# FCC CLASS II PERMISSIVE CHANGE REQUEST LETTER

**RE: FCC Permissive II Change Request for Company:** Hangzhou Tuya Information Technology Co., Ltd **FCC ID:** 2ANDLTY-R8815

(1) PCBA photo:

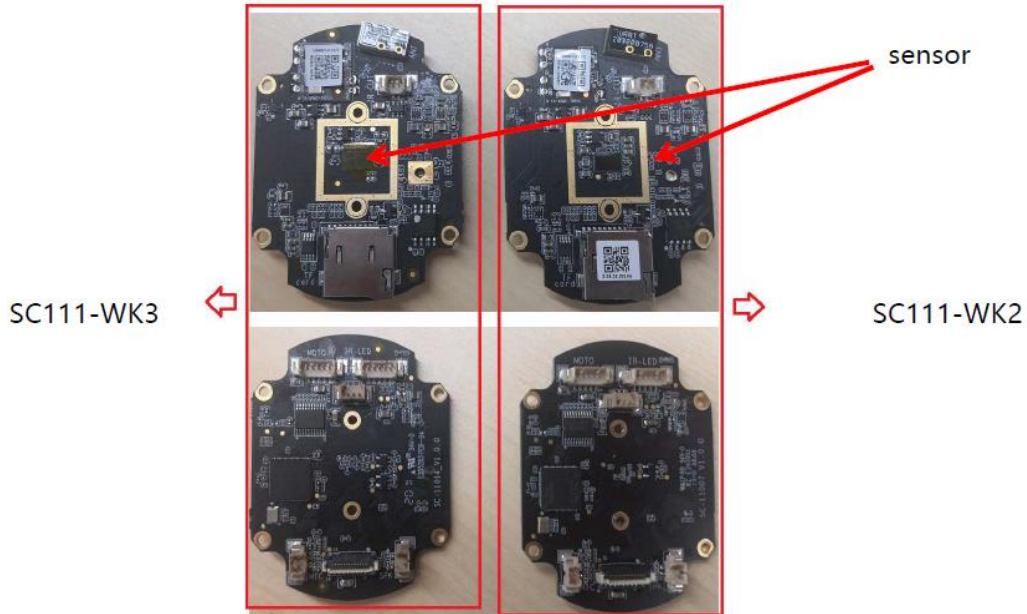
2. Add a new model number SK111-WK3.  
Compare with original model, the new model have different sensor, sensor board and PCB layout, as below.  
The schematic is the same.
